BOARD OF APPEALS

Wednesday, November 8, 2023

Case: **V23-0022 – 220 Zeblin Road**
Staff Contact: LaQuita Williams (lwilliams@sandyspringsga.gov)
Report Date: August 23, 2023

Request for a Variance from Section 9.4.3.A.2.a to allow tiered retaining walls to be placed less than four feet apart.

Aerial image of the angled portion of the retaining walls

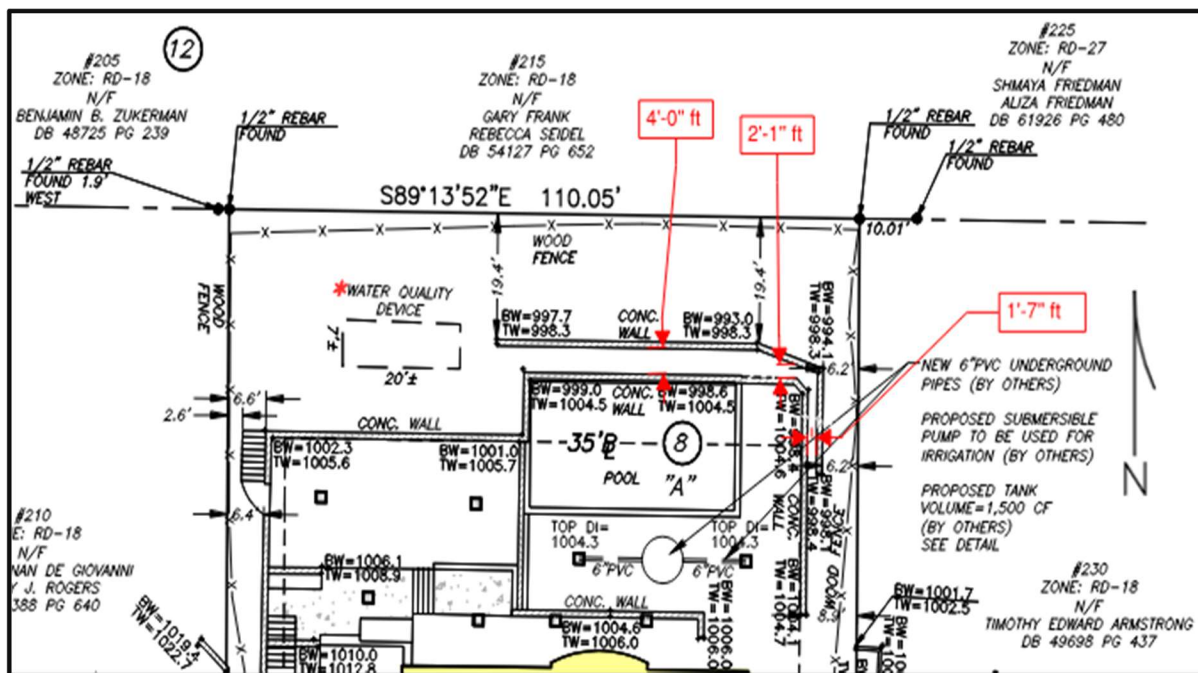
The applicant is seeking a variance from section 9.4.3.A.2.a to allow tiered retaining walls to remain less than four feet apart. The applicant previously submitted and obtained a permit in 2020 for these retaining walls however, the approved plans had not been adhered to, and the walls were constructed less than four (4) feet apart. The as-built survey revealed that the tiered retaining walls did not meet the required code regulations.

Per the Sandy Springs Development Code, Section 9.4.3.A.2.a. *Spacing – Distance* – Retaining walls must be separated horizontally by at least four (4) feet from other retaining walls (measured from the back of the lower wall to the front of the upper wall). This horizontal separation area must be graded to capture stormwater and not sloped such that stormwater will run off. The stormwater design must be included with the retaining wall permit plans.

The intent of this request is to permit the installed tiered retaining walls that are less than the four (4) feet apart required by the development code.

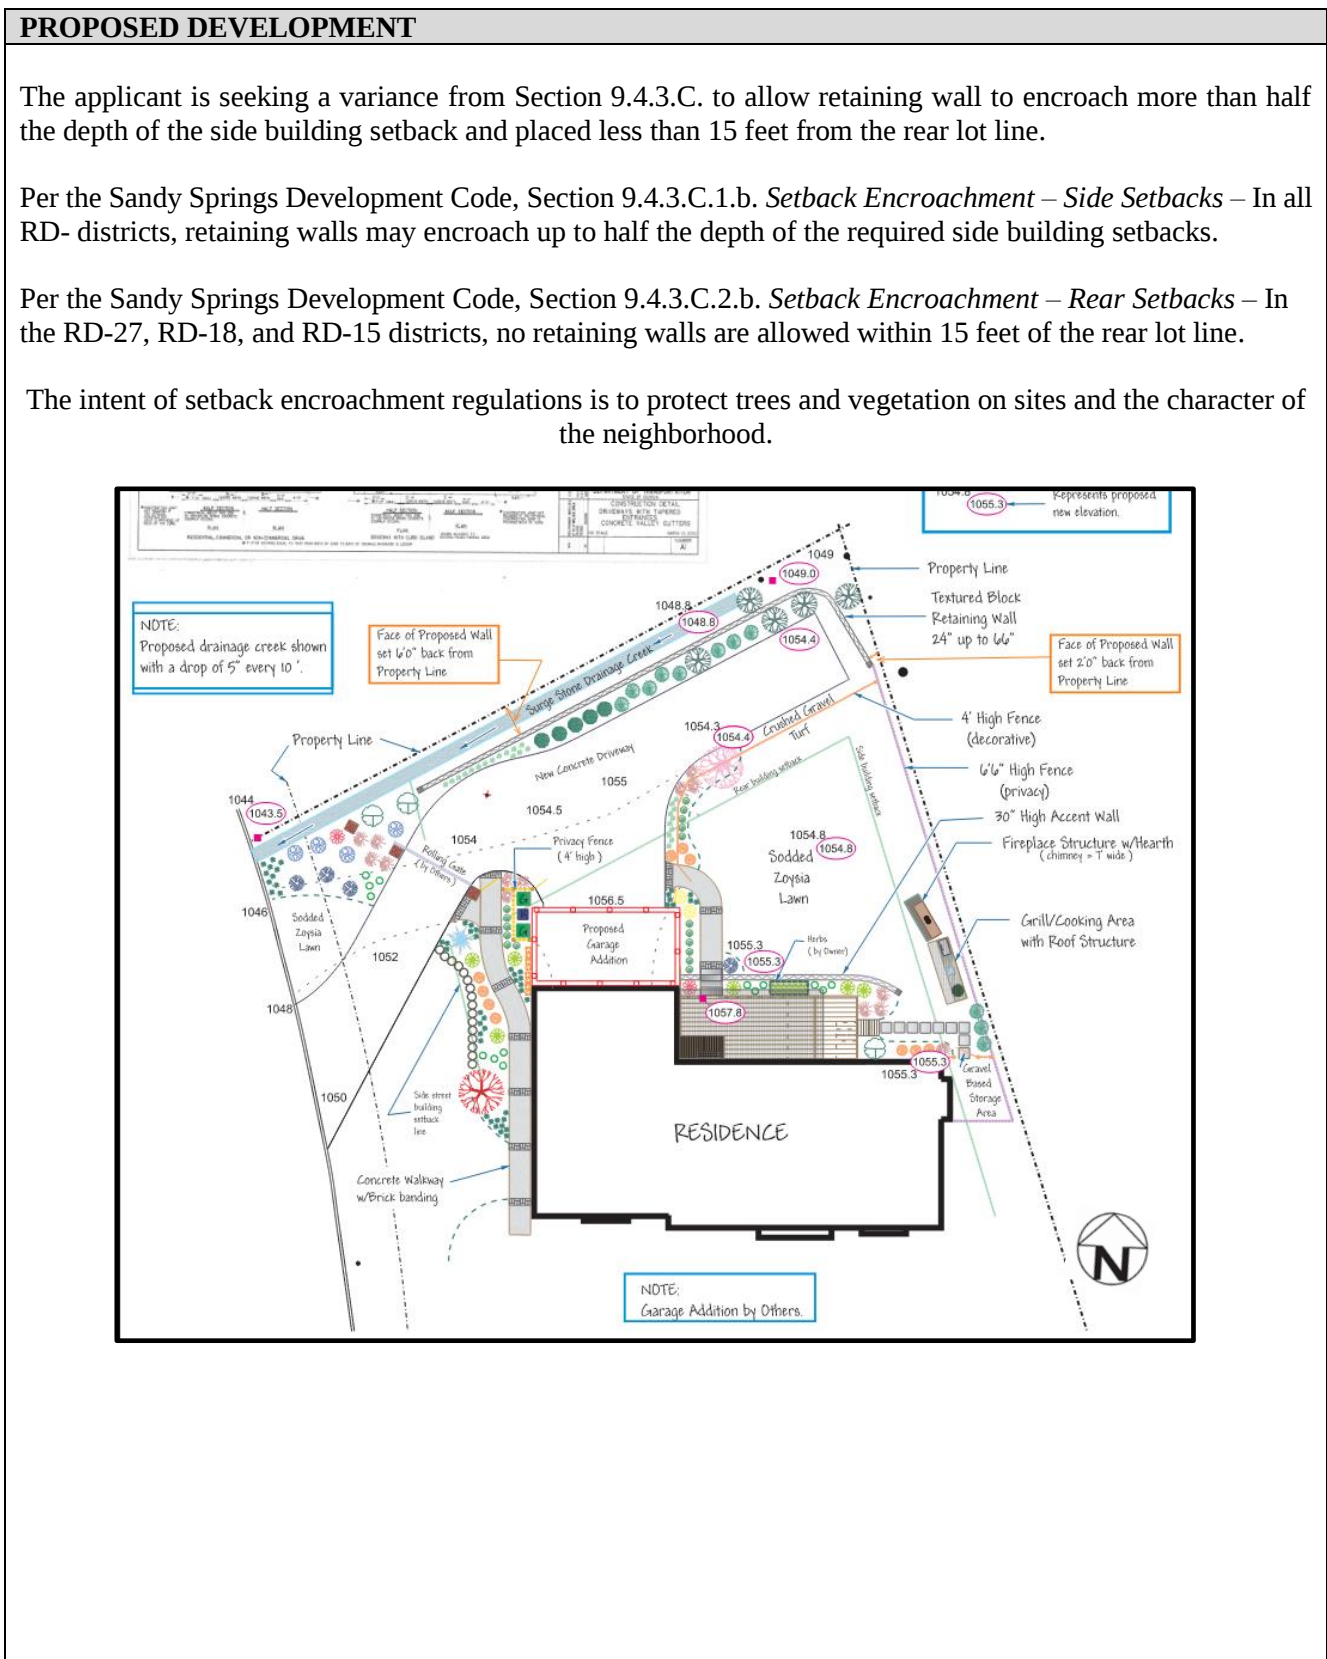
The applicant is seeking a variance from Section 9.4.3.C. to allow retaining wall to encroach more than half the depth of the side building setback and placed less than 15 feet from the rear lot line.

Per the Sandy Springs Development Code, Section 9.4.3.C.1.b. *Setback Encroachment – Side Setbacks* – In all RD- districts, retaining walls may encroach up to half the depth of the required side building setbacks.

Per the Sandy Springs Development Code, Section 9.4.3.C.2.b. *Setback Encroachment – Rear Setbacks* – In the RD-27, RD-18, and RD-15 districts, no retaining walls are allowed within 15 feet of the rear lot line.

Site Plan

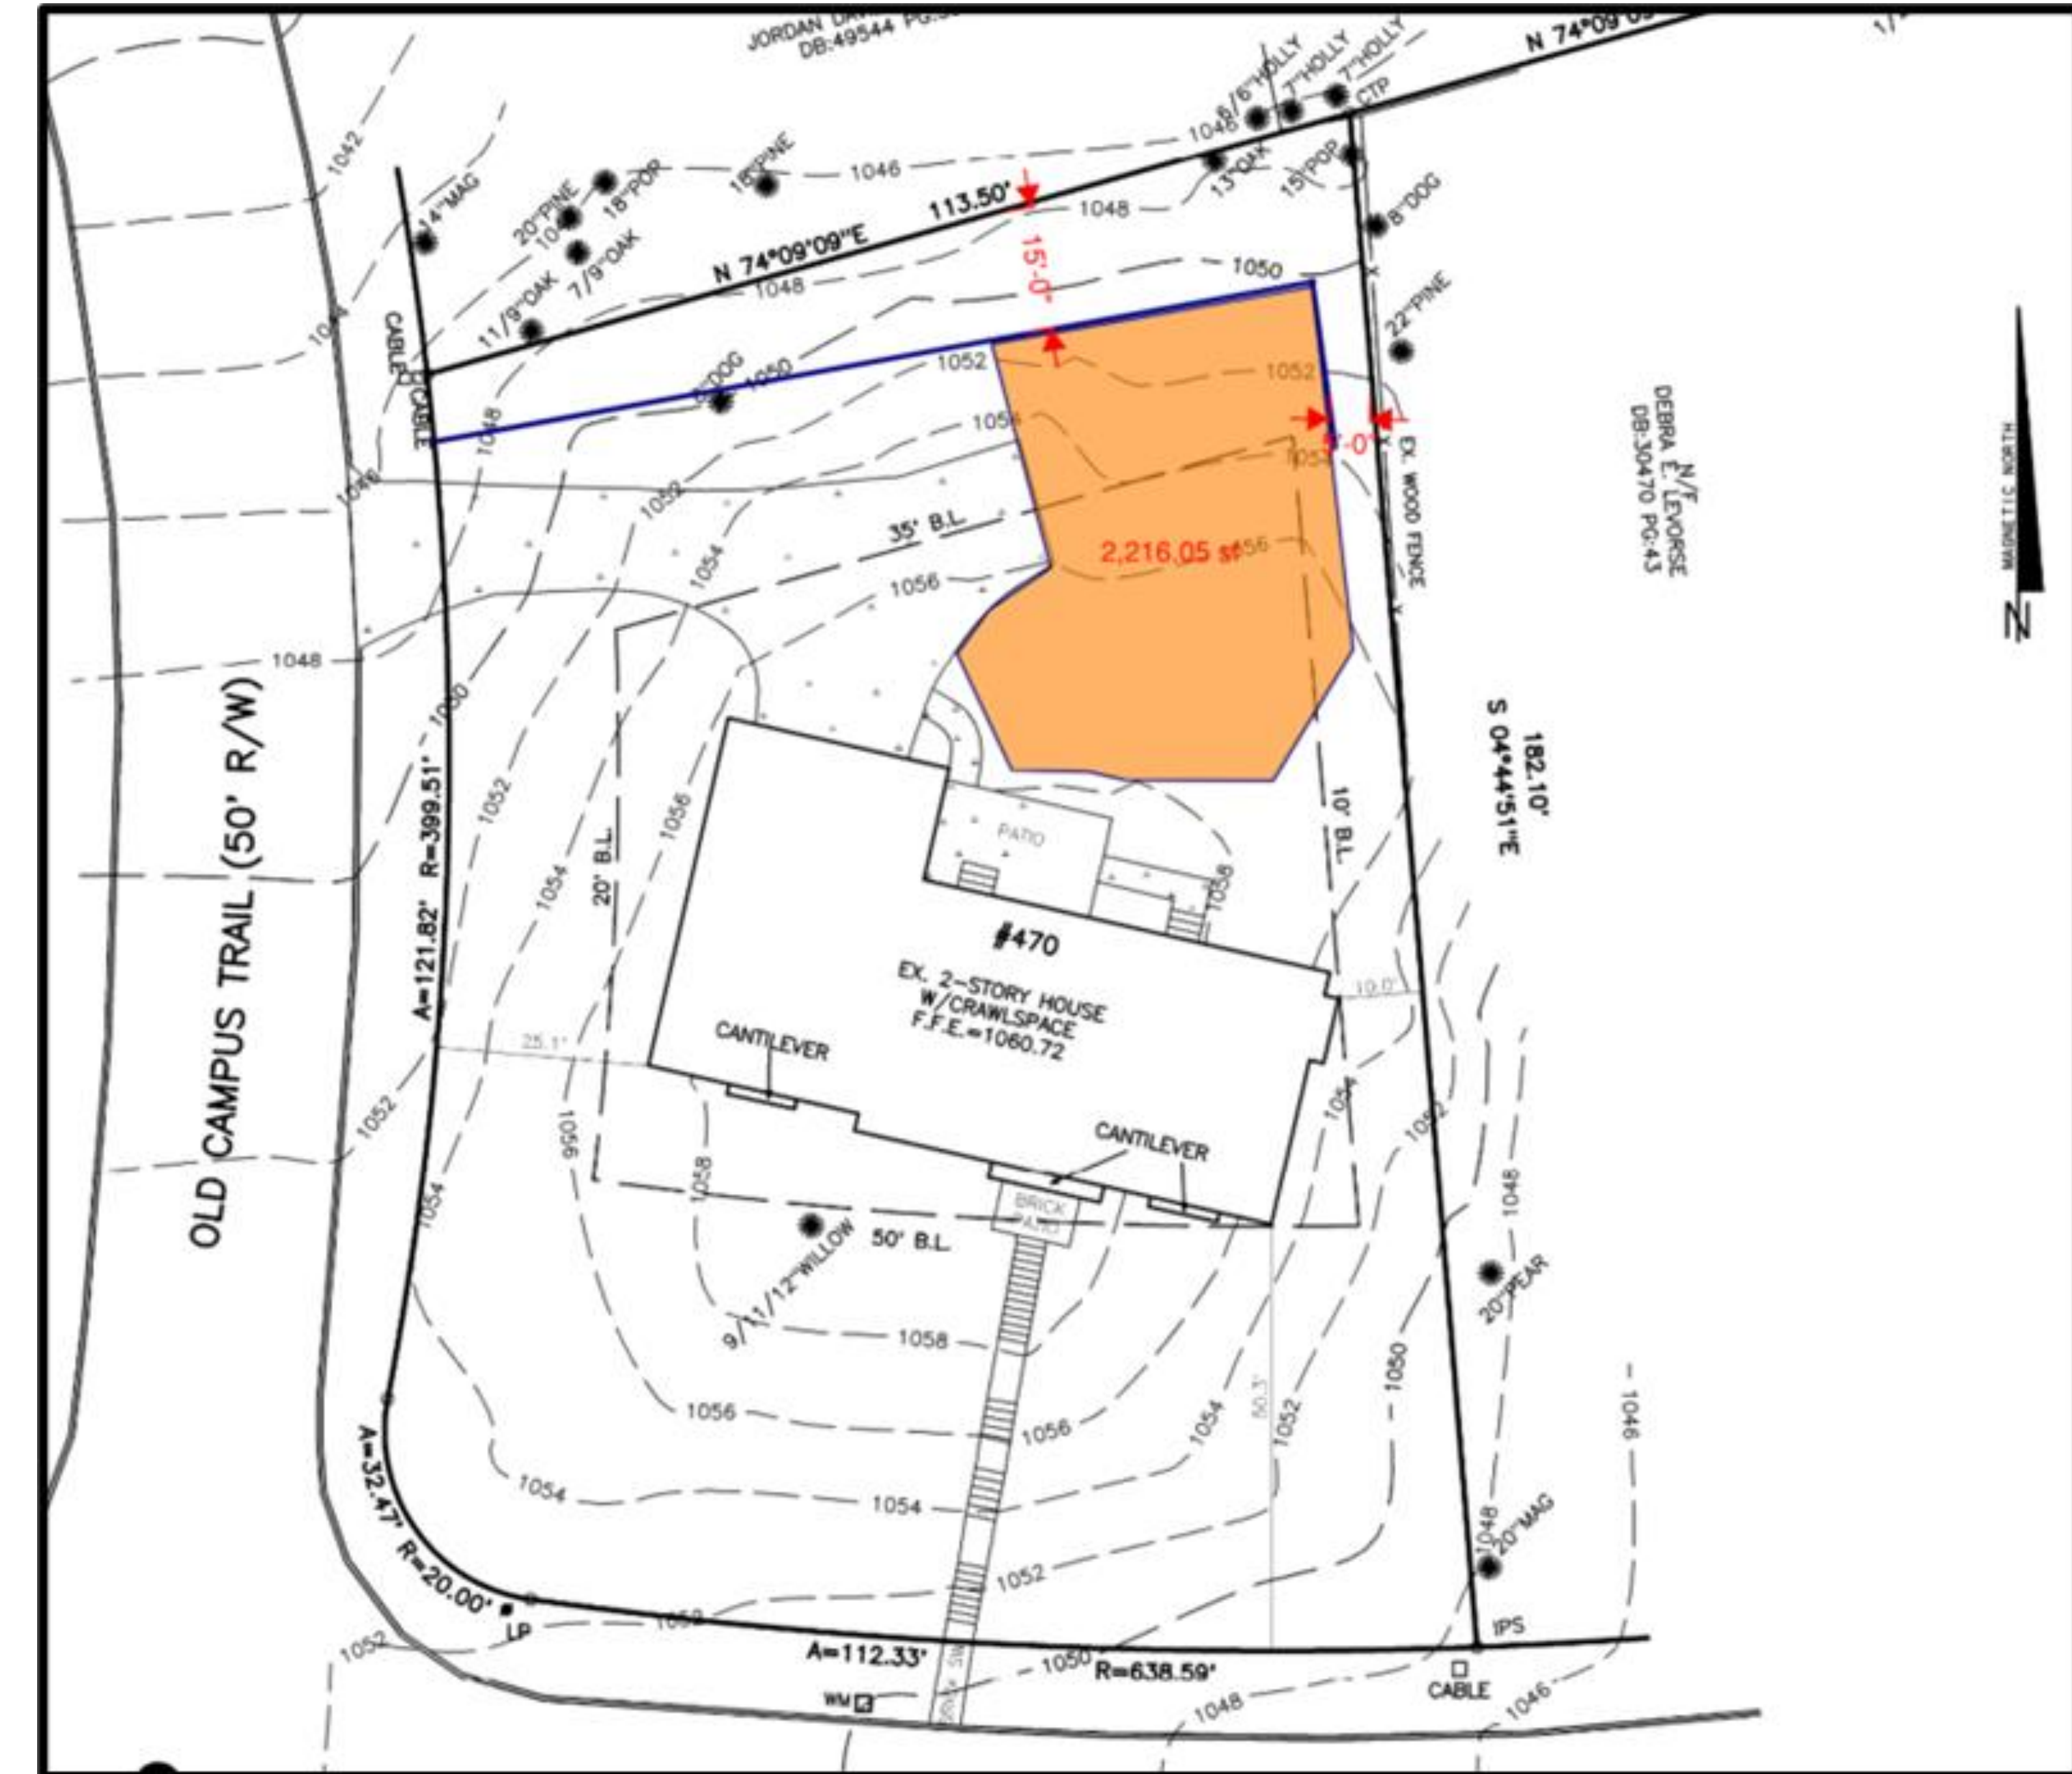
- **The application of this Development Code would create an unnecessary hardship, and not merely an inconvenience to the applicant; or;**
 - It is Staff's view that the application of the development code does not constitute a hardship. The existing driveway provides sufficient space that does not required a retaining wall.
